Preliminary Change Request for the Chromatic Sextupoles and Trim Quadrupole Elements of the SNS Accumulator Ring

BNL/SNS TECHNICAL NOTE

NO. 075

May 30, 2000

Figure 3: Lattice functions of the SNS accumulator ring for the nominal tunes (6.3,5.8) using two families of sextupoles. The beta and dispersion functions are strongly perturbed for off-momentum cases.

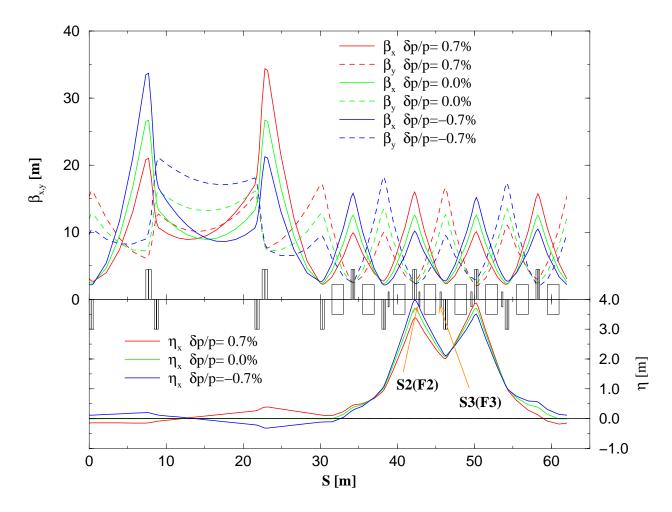
Two families of sextupoles, placed at high-beta and high-dispersion regions, can control the linear chromaticity of the ring. The sextupoles however may strongly affect the first and second order of the beta and dispersion functions dependence on the momentum spread, introducing strong "beta/dispersion waves" and, thereby, reducing the dynamic aperture. In addition, this beta/dispersion variation will increase the first and higher order terms of the chromaticity. This is clearly shown in figure 3: with a two-family scheme, the optical distortion in β -function is as large as 30% for off-momentum orbits.

Figure 4: Lattice functions of the SNS accumulator ring for the nominal tunes (6.3,5.8) using 4 families of sextupoles. The beta and dispersion wave has been minimized by the introduction of the 2 supplementary sextupole families.

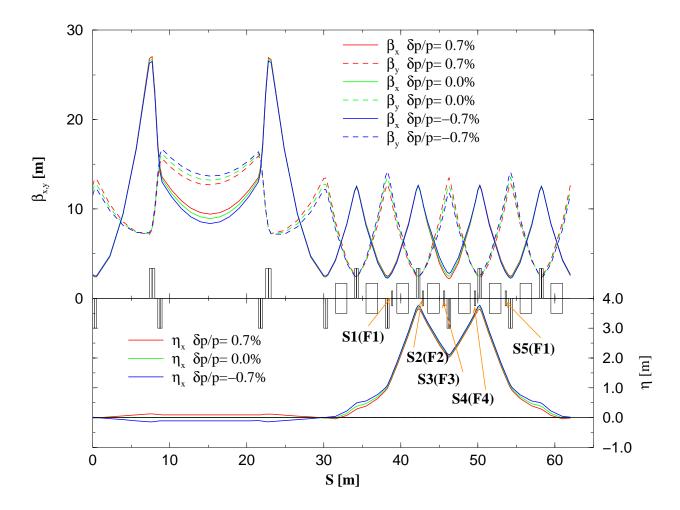
In order to minimize the dependence of the beta, the dispersion functions and the chromaticity on $\delta p/p$, additional families of sextupoles are required. In the proposed chromaticity correction scheme, three of the sextupoles are powered independently and two of them in

series, forming a total of four families. With a four-family scheme, the off-momentum optics is greatly improved, and the β -wave is minimal (Fig. 4).

Figure 5: Sextupole strengths for the four families of chromatic sextupoles versus the chromaticity. The maximum values are within the strength requirements (Table 2.1).

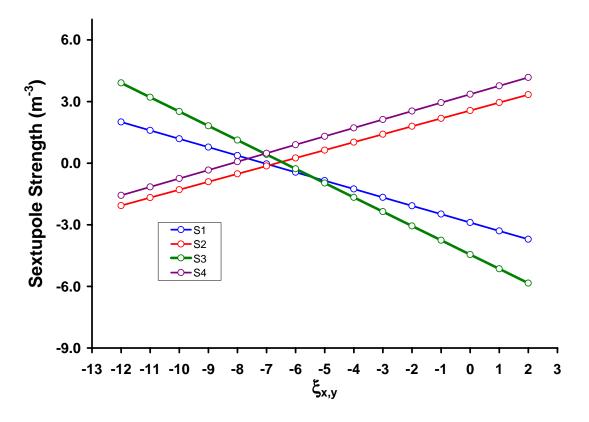
By using the HARMON module of the MAD program [4], we have computed the required strength of the four families of sextupoles in order to adjust the horizontal and vertical chromaticity $\xi_{x,y}$ to a wide value range and at the same time to minimize the optics functions' perturbation (Fig. 5). We observe that the sextupole strengths for the most extreme cases are less than 6m^{-3} . Thus, the strength requirements of 8.3m^{-3} , given in Table 2.1, are sufficient to handle the chromaticity/optics control, leaving a comfortable 20% margin.

Figure 6: Anharmonicities versus the chromaticity. The maximum values are within 5% of the ones produced by the quadrupole fringe-fields.

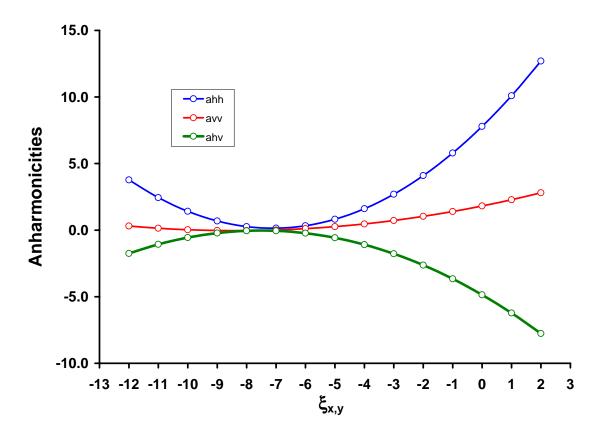
three quantities have been computed for all range of chromaticity values and plotted Fig. 6. The maximum anharmonicity values are found to be a factor of five smaller than the ones introduced by the quadrupole fringe-fields [5], indicating that the introduction of chromatic sextupoles will not have an important non-linear impact on the SNS ring. This residual octupole-like tune-shift can be corrected by dedicated octupole correctors [5]. Additional tracking studies are in progress in order to further justify the small impact of the chromatic sextupoles in the non-linear dynamics of the SNS ring.
